Subject: AP1000 Response to Request for Additional Information

1. Response to Request for Additional Information on SRP Section TR44

AP1000 TECHNICAL REPORT REVIEW

RAI Response Number: RAI-TR44-008

FIGURE TR44-9.2; ELEVATION VIEW OF
NEW STORAGE RACK CELLS

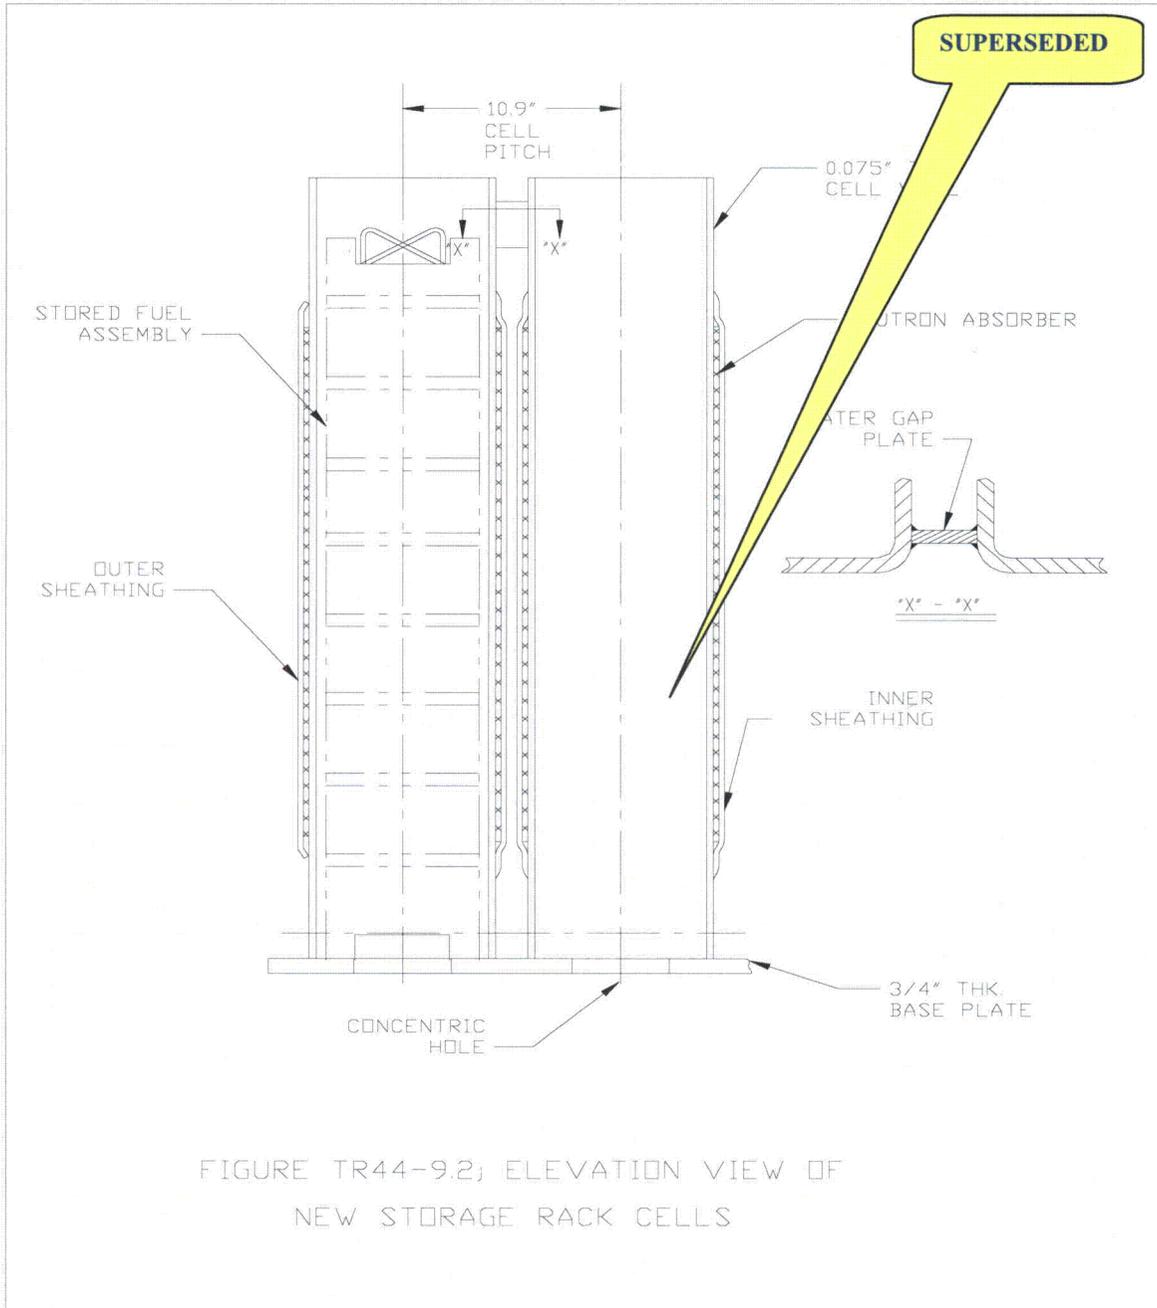
Insufficient descriptive information has been included in the new fuel report to permit an adequate review of the structural/seismic analysis of the new fuel rack. Please provide descriptive information including plans and sections showing the new fuel rack and vault walls. All of the major features of the rack including the cell walls, baseplate, pedestals, bearing pads, neutron absorber sheathing, any impact bars, welds connecting these parts, and any other elements in the load path of the rack should be shown on one or several sketches. These sketches should also indicate related information which includes key: cutouts, dimensions, material thicknesses, and gaps (fuel to cell, rack to walls). In addition to the above, for review of postulated fuel handling drop accident and quantification of the drop parameters, sketches with sufficient details for the fuel handling system should be provided.

~~Figures TR44-9.1 through TR-44-9.5 provide additional descriptive information on the new fuel rack and New Fuel Storage Pit floor and walls. The new fuel handling system is still in final design and no sketches are available. The quantification of the drop parameters has been established and analyzed in Technical Report Number 44. A conservative drop height of 36 inches has been assumed even though the most likely drop height will not exceed 18 inch above the new fuel rack. The total drop weight is 2,027 pounds, which consist of a new fuel assembly, control assembly and new fuel handling tool.~~

Figure 9.1-1 (Sheet 1 of 2)
New Fuel Storage Rack Layout (72 Storage Location)

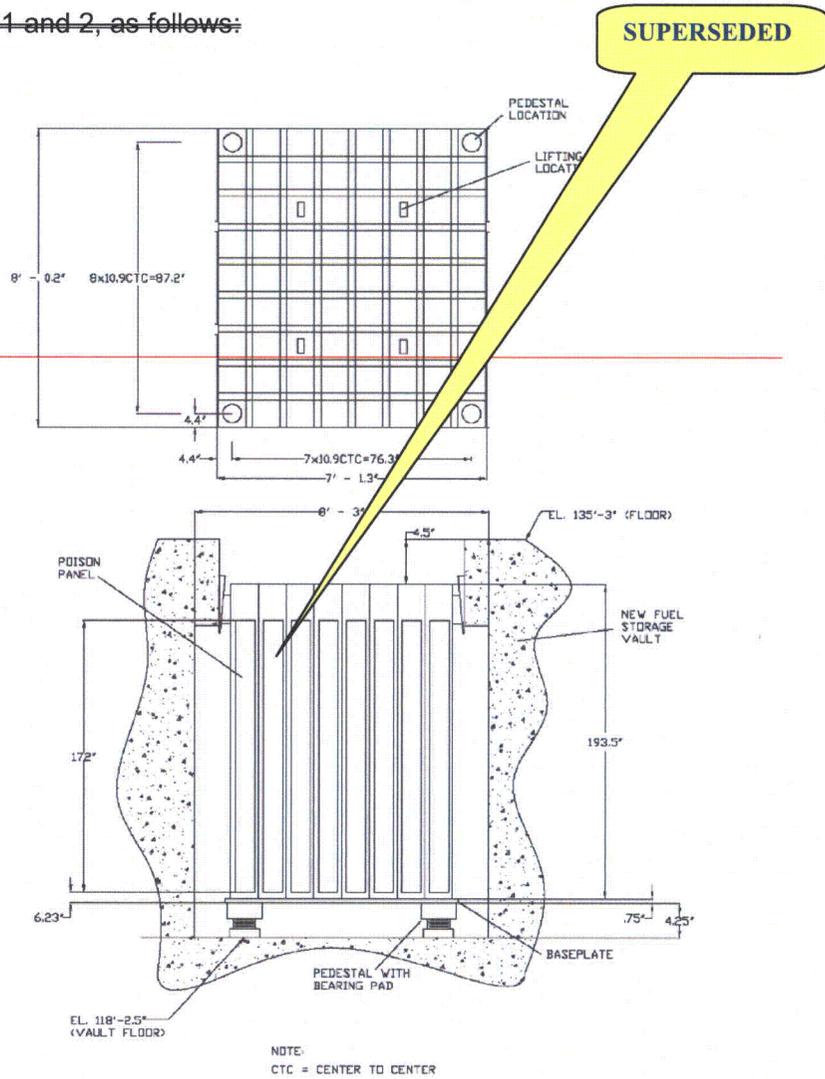
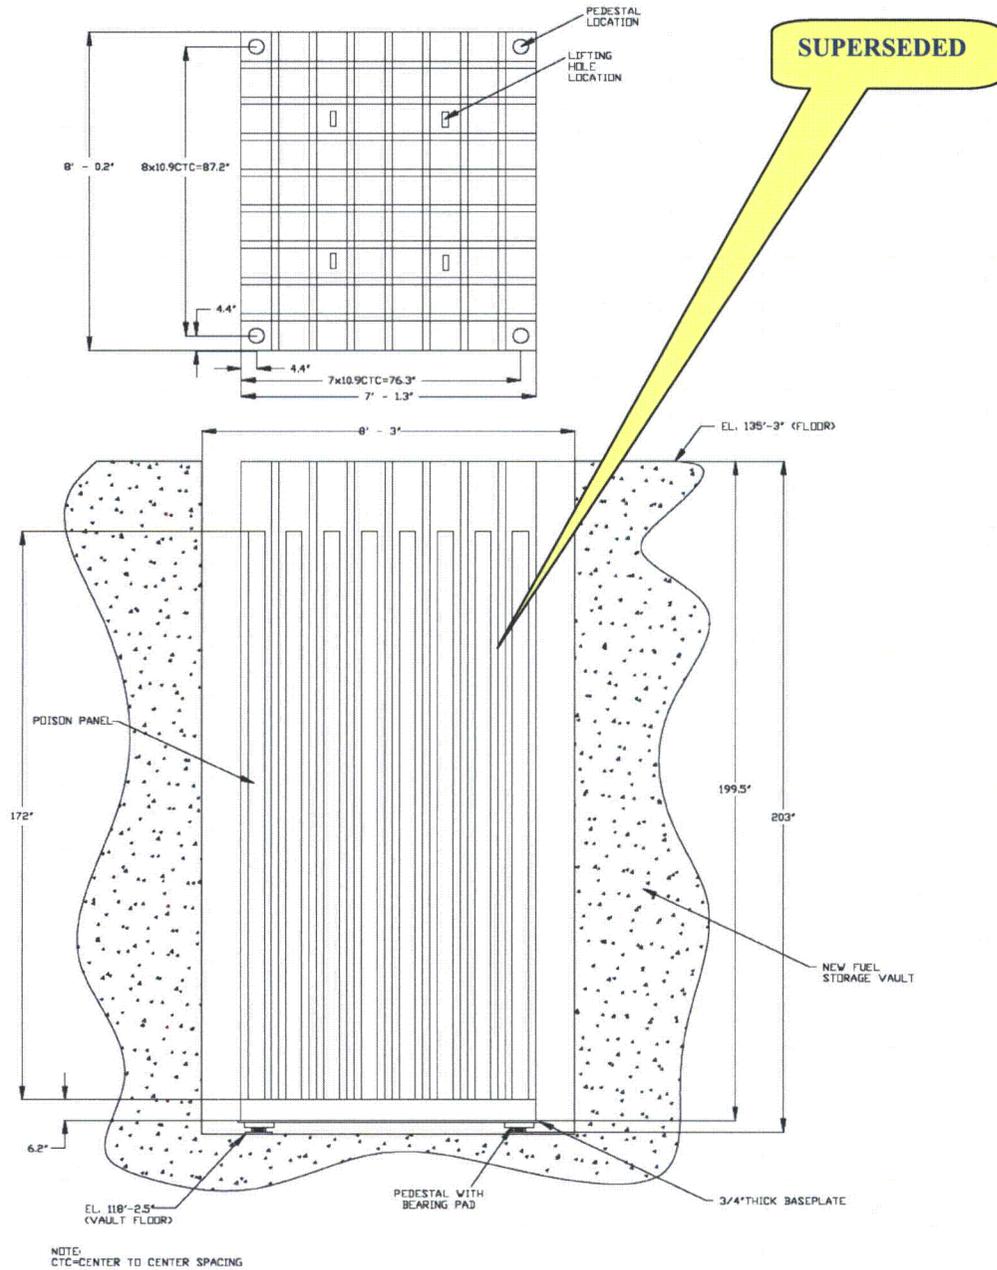
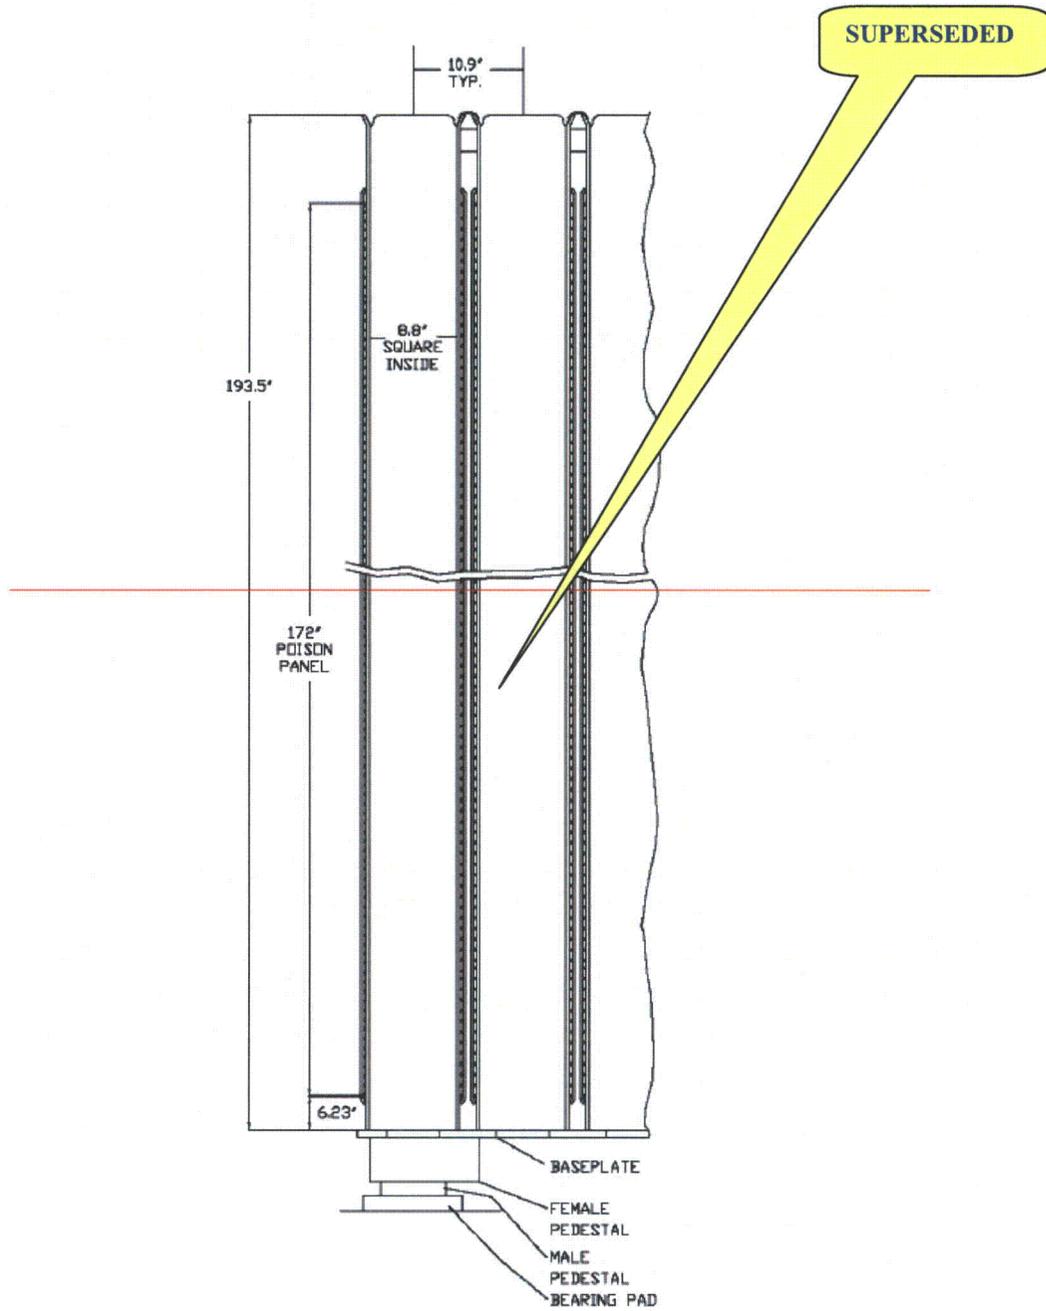
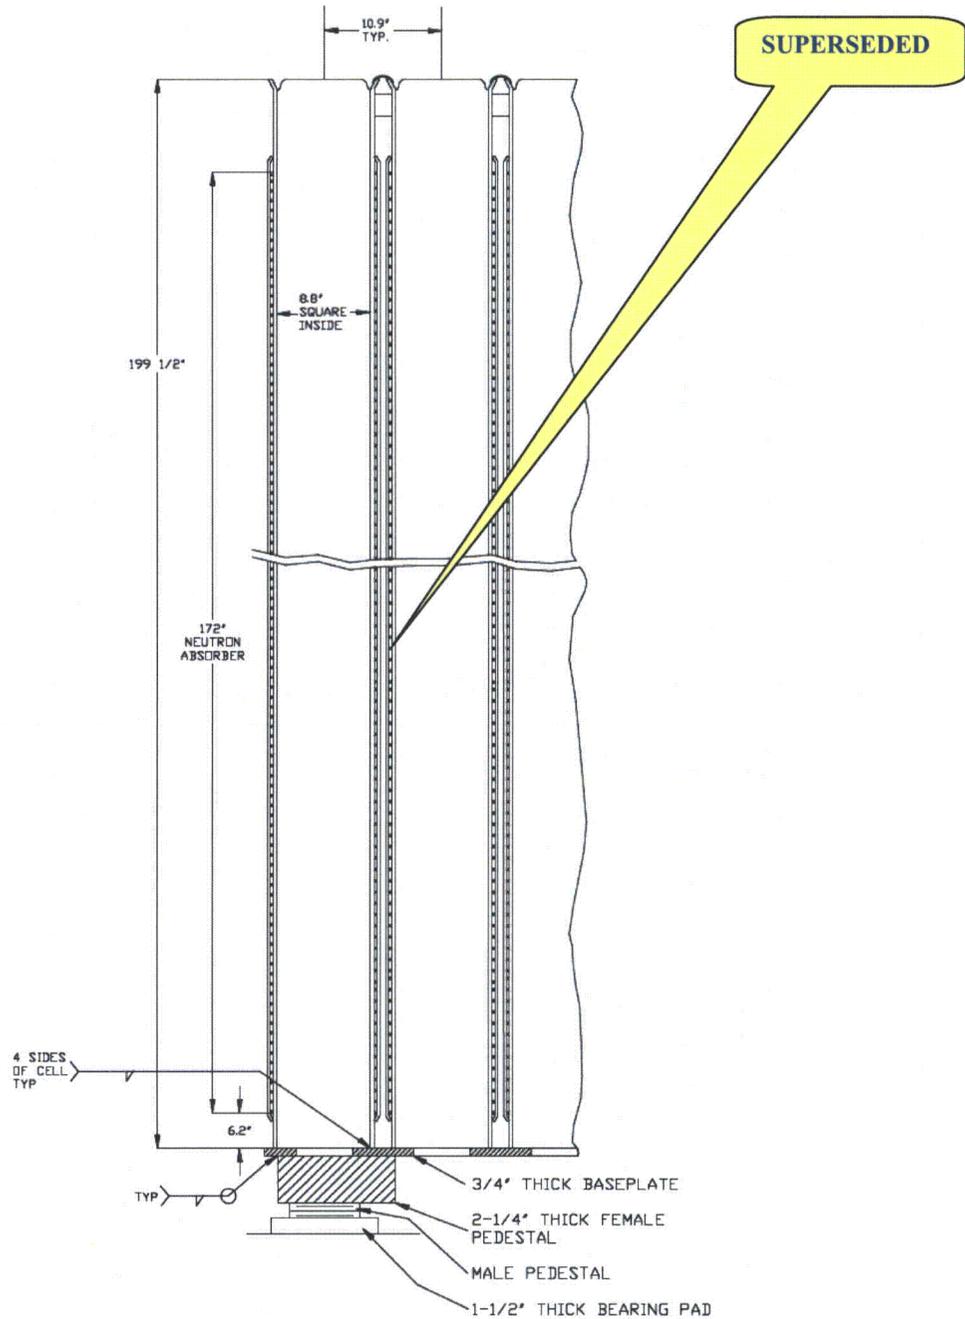
During the June 2010 audit, the NRC requested that dimension and gap information for the new fuel racks be clarified between the three similar RAIs (RAI-TR44-09, RAI-TR44-017, RAI-TR44-25) to show consistency and alignment to the current design basis shown in DCD Figure 9.1-1.

~~The two figures shown in the DCD and TR markup sections provide updates of the layout and cross section of the new fuel storage rack. The figures replaced Figure 2-1 of TR44 and DCD Figure 9.1-1, Sheets 1 and 2; see the DCD and TR markup sections for details.~~

The most recent change to DCD Figure 9.1-1 (Sheet 1 of 2) is included in the response to RAI-TR44-17 Revision 3.

The DCD Figure 9.1-1 (Sheet 2 of 2) is not modified by any revision of comments in this RAI response. This figure and page were included into DCD Revision 17 (Letter DCP/NRC 2202) and remain applicable to the new fuel rack design.

Revise Figure 9.1-1, Sheets 1 and 2, as follows:

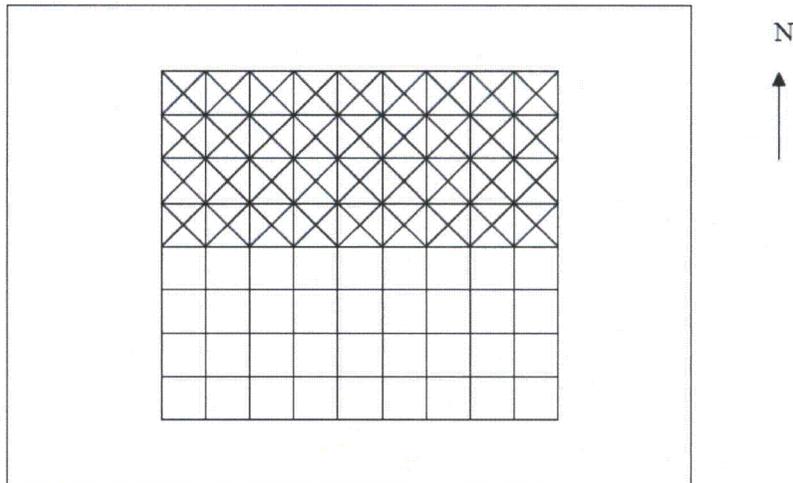
After NRC reviewed the supplemental RAI response from the August 2009 audit, they requested that the RAI response be revised to delete the argument that the partial loading case is not controlling.

Following the August 2009 audit with the NRC, Westinghouse has completed an additional run (Run Number 4) to examine the effects of the worst possible partial rack loading scenario (half full, all on one side, as depicted in the following figure). The results of this additional run will be included in Revision 2 of TR-44. Also, DCD Section 9.1.1.2.1, Item A, is modified to indicate that a partially filled loading case was evaluated.

Replace DCD Figure 9.1-1 (Sheet 1 of 2) entitled "New Fuel Storage Rack Layout (72 Storage Locations)" with the following figure.

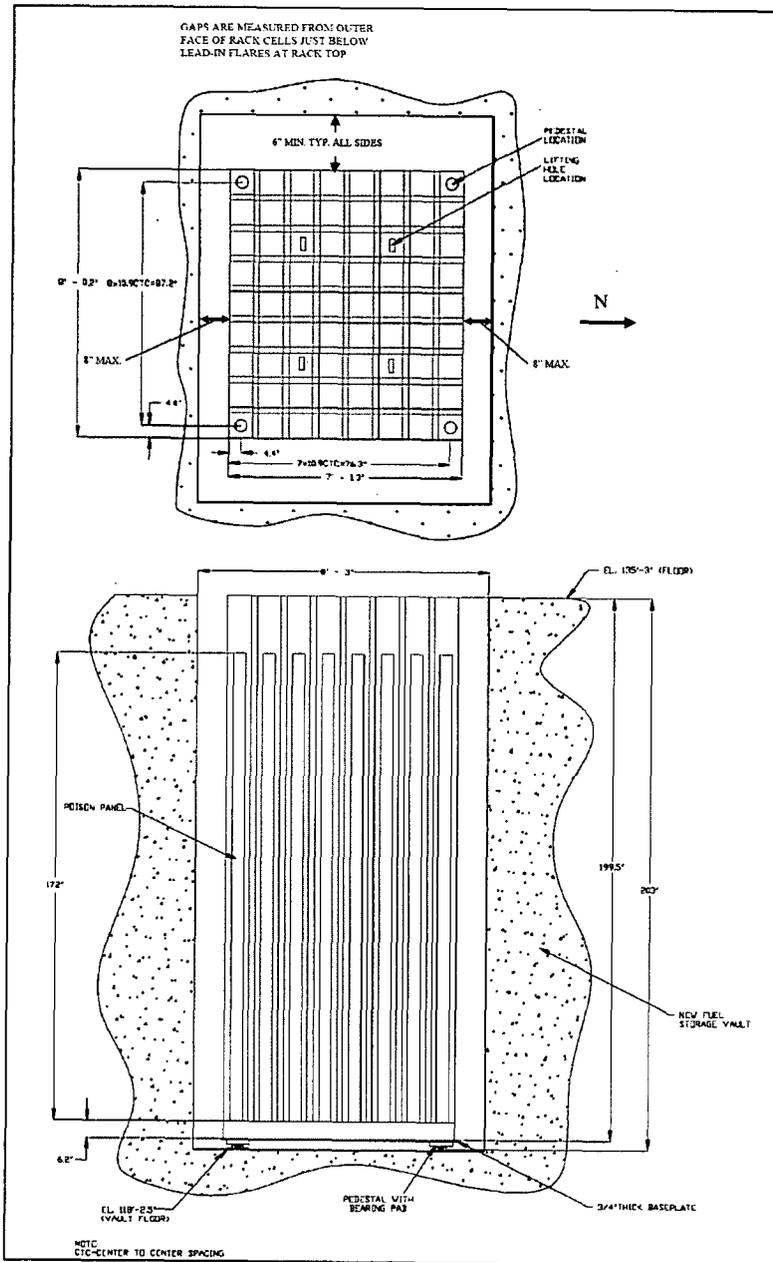
What are the gaps and tolerances for each of the gaps between the fuel assembly and cell wall, and between the rack and vault wall? What are the assumed initial locations of the various components (fuel assemblies and rack) and what is the technical basis for this assumption. Were any studies done for different initial conditions (considering tolerances); if not, explain why it was not necessary. Are there requirements in the DCD to ensure that the assumed gaps (considering tolerances) are maintained throughout the operating license period?

During the June 2010 audit, the NRC requested that dimension and gap information for the new fuel racks be clarified between the three similar RAIs (RAI-TR44-09, RAI-TR44-017, RAI-TR44-25) to show consistency and alignment to the current design basis shown in DCD Figure 9.1-1.

The current nominal placement of the New Fuel Storage Rack within the New Fuel Storage Pit based on current seismic analysis and drawings (References 2 and 3) is described below:

To ensure that criticality safety assumptions are met, a maximum rack-to-wall gap of < 8 ” has been added to the North and South walls, where there are no neutron absorber panels. The 8” maximum gap precludes the possibility of a fuel assembly (with minimum nominal fuel assembly dimensions greater than 8.4” square) being inadvertently placed into the space next to the exterior of the New Fuel Storage Rack on the North and South faces where no neutron absorber panels exist. There are neutron absorber panels provided on the East and West faces; so there is no need to limit the maximum gap in these directions.

The following change to DCD Figure 9.1-1 (Sheet 1 of 2) represents the current design basis shown in TR44 (Reference 1).
